REFERENCE:	TSB: 08-014-25 REV. E GROUP: 08 - Electrical	Date:	December 18, 2025	REVISION:	08-014-25 REV. D
VEHICLES AFFECTED:	2024 (KM) Jeep Wagoneer S This bulletin applies to vehicles equipped with 400V G2500 FR/RR Elec Drive Motors (Sales Code ELD).			MARKET APPLICABILITY: <input checked="" type="checkbox"/> NA <input type="checkbox"/> MEA <input type="checkbox"/> SA <input type="checkbox"/> IAP <input type="checkbox"/> EE <input type="checkbox"/> CH NOTE: This bulletin applies to the North America market.	
CUSTOMER SYMPTOM:	<p>Customers may experience a Malfunction Indicator Lamp (MIL) illumination and the vehicle may exhibit/set one or more of the following Diagnostic Trouble Codes (DTCs):</p> <ul style="list-style-type: none"> ● **B12B4-00 - Charge Status Indicator Module Internal.** ● C10FA-00 - Wheel Hub disconnect Actuator Performance Left. ● C10FB-00 - Wheel Hub disconnect Actuator Performance Right. ● C10F8-00 - Left Front Wheel Hub Disconnect Actuator Position Sensor Circuit Range/Performance. ● C10F9-00 - Right Front Wheel Hub Disconnect Actuator Position Sensor Circuit Range/Performance. ● P061B-00 - Internal Control Module Torque Calculation Performance. <p>Customers

Fig. 1
Cooling Fan Assembly

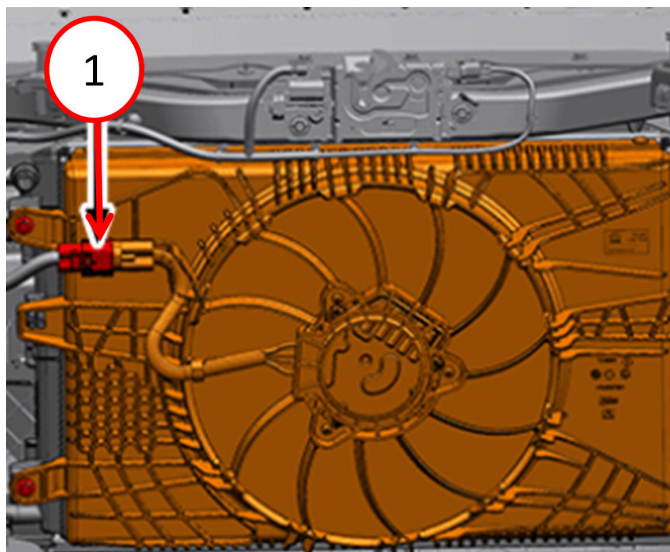
4. Disconnect the cooling fan wire harness connector [Fig. 1](#).

34. Connect the cooling fan wire harness connector [Fig. 1](#).
